UNITED STATES PATENT AND TRADEMARK OFFICE

Office Action Summary

09/738,979

UMEMOTO ET AL.

Fig.3

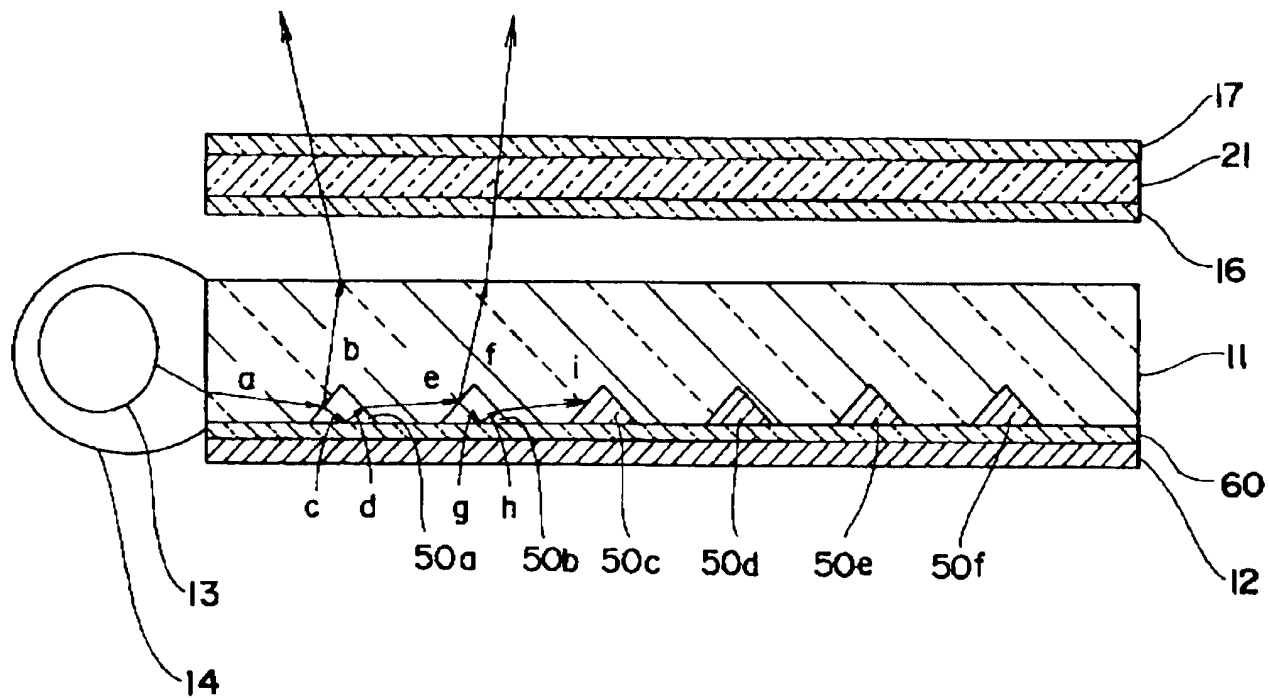
As to claim 1, Yuuki discloses in Figures 2, 3, and 4 (col. 5, line 19 through col. 8, line 52, especially col. 5, lines 45-55) a liquid-crystal display (LCD) device comprising: a transmission type liquid-crystal display panel, 21, including a liquid-crystal cell; a light source, 13, disposed on at least one side surface of said liquid-crystal display panel; and a light guide plate, 11, (Applicant's optical path changing sheet) disposed on a back side opposite to a visual side of said liquid-crystal display panel and having optical path changing slopes, 50a through 50f, by which incident light from said light source is reflected toward said visual side of said liquid-crystal display device (ray traces b and f).

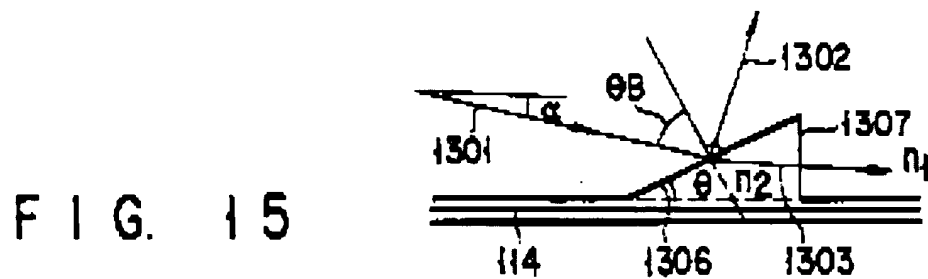
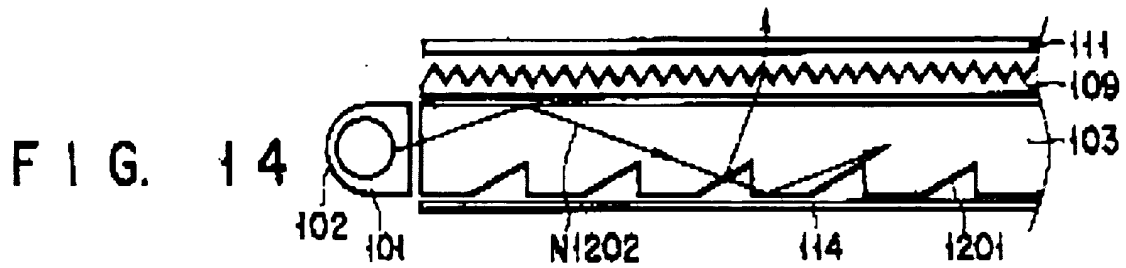
As to claim 2, Yuuki discloses in Figures 2, 3, and 4 (col. 5, line 19 through col. 8, line 52, especially col. 5, lines 19-22) the liquid-crystal display device according to claim 1, wherein said liquid-crystal display panel further includes a polarizer, 16, disposed on one or each, 17, side of said liquid-crystal cell, 21.

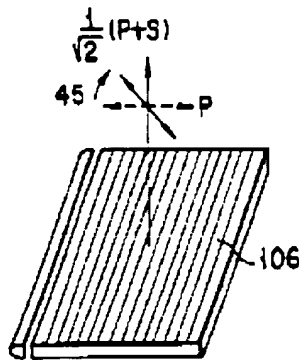
As to claims 7 and 8, Taira discloses in Figures 14 and 15 (embodiment 11, col. 13, line 50 through col. 15, line 16, especially col. 14, lines 43-64) the liquid-crystal display device according to claim 1, wherein said optical path changing sheet includes repetitive prismatic structures having optical path changing slopes facing said light source at an inclination angle, θ , of from 3 to 56 degrees (includes Applicant's 35 to 48 degrees of claim 7 and includes Applicant's 38 to 45 degrees of claim 8) with respect to said sheet plane.

Taira is evidence that ordinary workers in the art of liquid crystals would find the reason, suggestion, or motivation to add an inclination angle of from 35 to 48 degrees or from 38 to 45 degrees to reflect light at Brewster's angle (col. 14, lines 43-54) towards the LCD and the viewer.

FIG. 10A

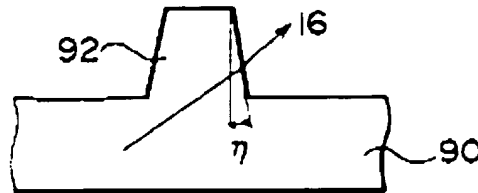
Miyashita teaches in Figure 10A the use of convex prismatic structures shaped substantially like a trapezoid in section to make manufacture by injection molding easier (col. 15, lines 58-67).

Miyashita is evidence that ordinary workers in the art of liquid crystals would find the reason, suggestion, or motivation to use convex prismatic structures shaped substantially like a trapezoid in section to make manufacture by injection molding easier.

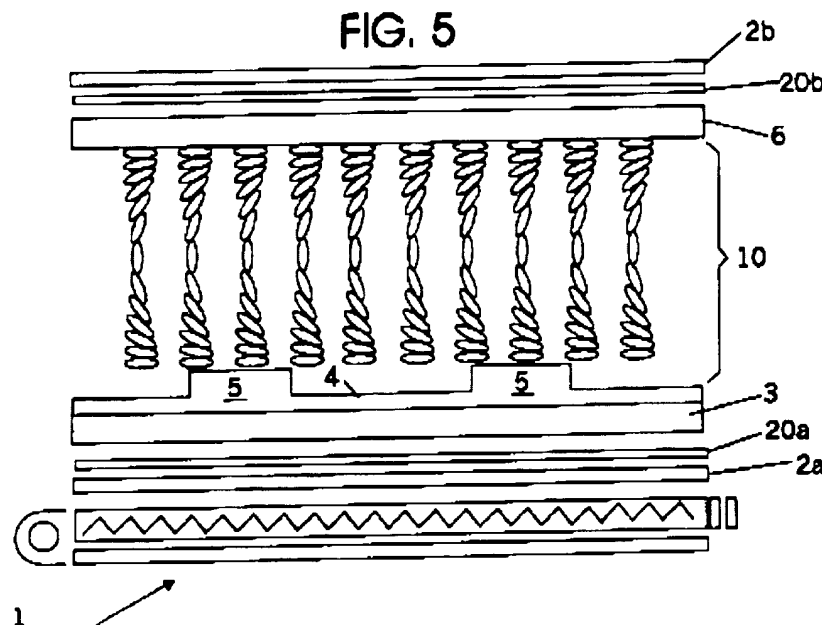
Therefore, it would have been obvious to one having ordinary skill in the art of liquid crystals at the time the invention was made to modify the optical path changing sheet of Taira with the convex prismatic structures shaped substantially like a trapezoid in section of Miyashita.
